CONSTRUCTION PLAN FOR PRIVATE STORM SEWER IMPROVEMENTS
NORTHBOROUGH 3rd ADDITION
 TO
THE CITY OF WICHITA, KANSAS
 GARY JANZEN, P.E. - CITY ENGINEER

As Built Plans
 Contractor: Accel Construction, LLC
 Inspector: Jim Duling, Poe & Associates, Inc.
 PDF By: JPD 4-18-2014

NORTHBOROUGH 3RD ADDITION
 STORM WATER DRAINAGE IMPROVEMENTS
 STORM SEWER-LINE NO. 1
 CONSULTING ENGINEERS
 CITY OF WICHITA, KANSAS
 GARY JANZEN, P.E. - CITY ENGINEER
 0184 PPD OCA NO. 607861

SHEET
 2 OF 9

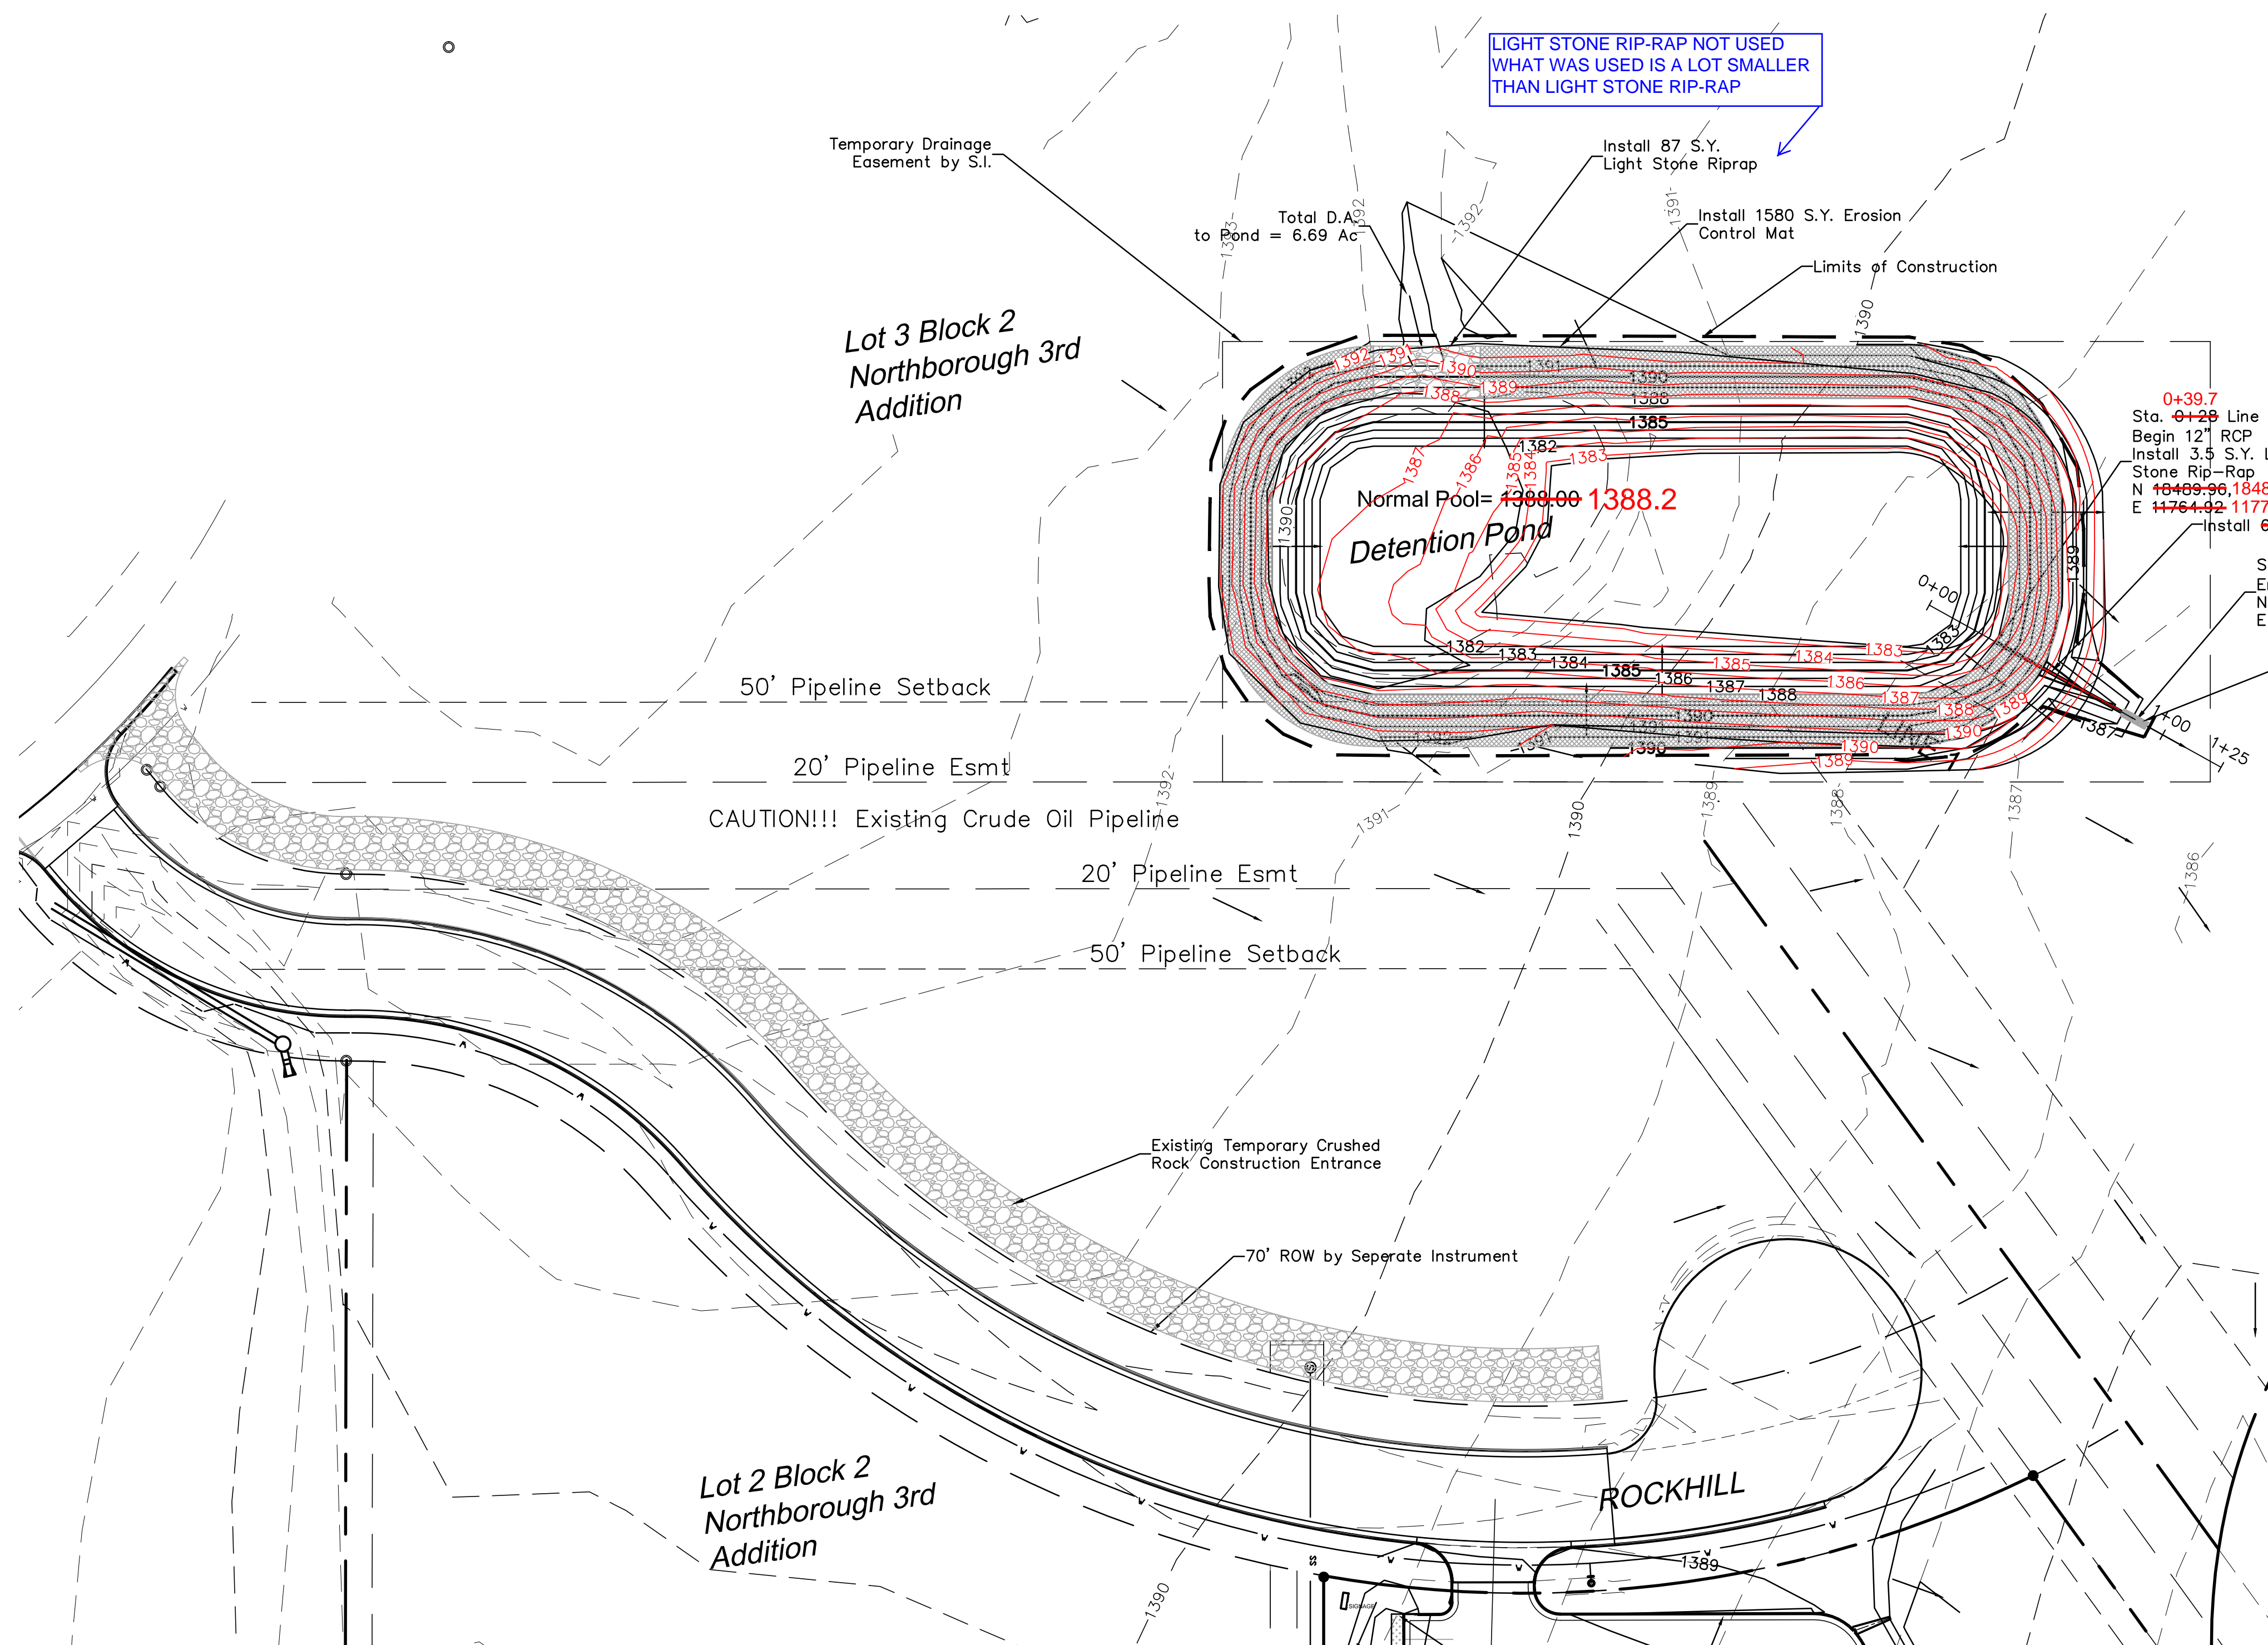
PVC PIPE WAS INSTALLED NOT RCP

LIGHT STONE RIP-RAP NOT USED
WHAT WAS USED IS A LOT SMALLER
THAN LIGHT STONE RIP-RAP

LIGHT STONE RIP-RAP NOT USED
WHAT WAS USED IS A LOT SMALLER
THAN LIGHT STONE RIP-RAP
